**Appendix I Responses to the External Peer Review of the
Proposed Desalination Amendment
Associated with the Draft Staff Report Including the
Draft Substitute Environmental Documentation
For the Proposed Desalination Amendment**

1. Ben R. Hodges, Ph.D. (BRH)

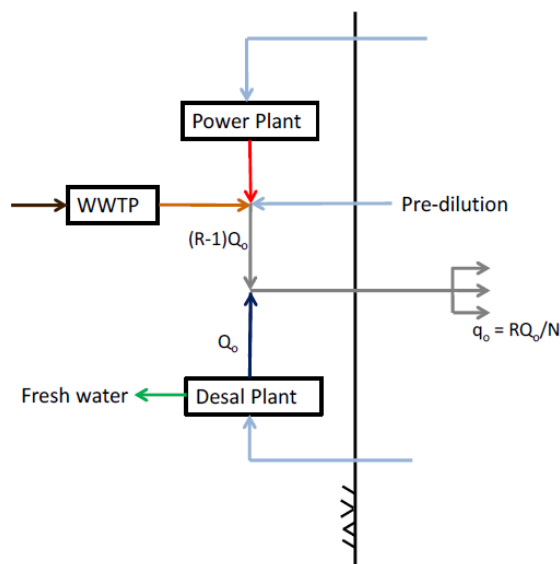
The above equations are for a single jet discharging just the brine from a desalination plant. The accompanying sketch depicts an arrangement where the discharged flow can be pre-diluted with either: i) seawater, ii) treated wastewater effluent, and/or iii) heated condenser cooling water from a power station, making a combined flow of RQ_o . The discharge is evenly distributed through N ports of a multiport diffuser making the flow per port equal to RQ_o/N . The reduced gravity of the combined flow is $[\Delta_o + (R-1)\Delta_p]/R$ where Δ_p is the reduced gravity of the pre-dilution flow, which is proportional to the pre-dilution excess salinity, i.e. $[g(\rho_p - \rho_a)/\rho_a] \sim \Delta s_p$, defined as positive for a dense flow. For example, if the pre-dilution comes from pure seawater $\Delta_p = \Delta s_p = 0$ while if it comes from treated wastewater effluent or heated condenser cooling water Δ_p and $\Delta s_p < 0$. Using Eqns 1b, 2b, the maximum plume height and the dilution are

Eqs 3-5 are exercised in the accompanying table. Note that for a given problem Q_o and Δ_o are fixed, while θ_o , R , u_o , N and Δ_p are design variables. Case 1 starts with base case parameters that do not meet a target near field dilution of 20 either for excess salinity Δs or excess concentration Δc (last two columns of the table). The remaining cases show that dilution increases (and a target of 20 can be easily achieved) by using a multi-port diffuser (increasing N ; Case 2), increasing discharge momentum (increasing u_o ; Case 3), pre-diluting the brine with neutrally buoyant seawater (increasing R with $\Delta_p = 0$; Case 4), and pre-diluting (co-mingling) the brine with relatively buoyant treated wastewater or heated water (increasing R and making $\Delta_p < 0$; Case 5).

So all of these options can provide improved dilution. On the negative side, increasing u_o and R may require deeper water depth or shallower discharge angle to avoid plume surfacing, while increasing N allows discharge in shallower water. These are capital cost issues. And increasing either u_o or R requires more pumping energy, an operating cost issue. Environmentally, increasing R causes more water to be withdrawn at the intake with potential impacts due to impingement and entrainment, as well as impacts on the discharge side due to turbulent shear. Increasing u_o by itself could also increase turbulent shear. But if you can use another effluent (i.e., treated wastewater or condenser cooling water) for pre-dilution, then you have already suffered the impacts with sourcing and using that water, and if you are going to discharge the other effluent to the ocean anyway, you might as well let it improve your dilution. In the case of treated wastewater, however, an evaluation should be made as to whether commingling is a more valuable use than re-use (direct or indirect).

To summarize, I certainly support the conclusion that diffusers and co-mingling can provide good near field dilution. Flow augmentation can also be used, but is somewhat less effective, and simply adjusting the exit velocity may also work. Because there are multiple environmental impacts to be minimized (intake entrainment/impingement, near and far field concentrations of
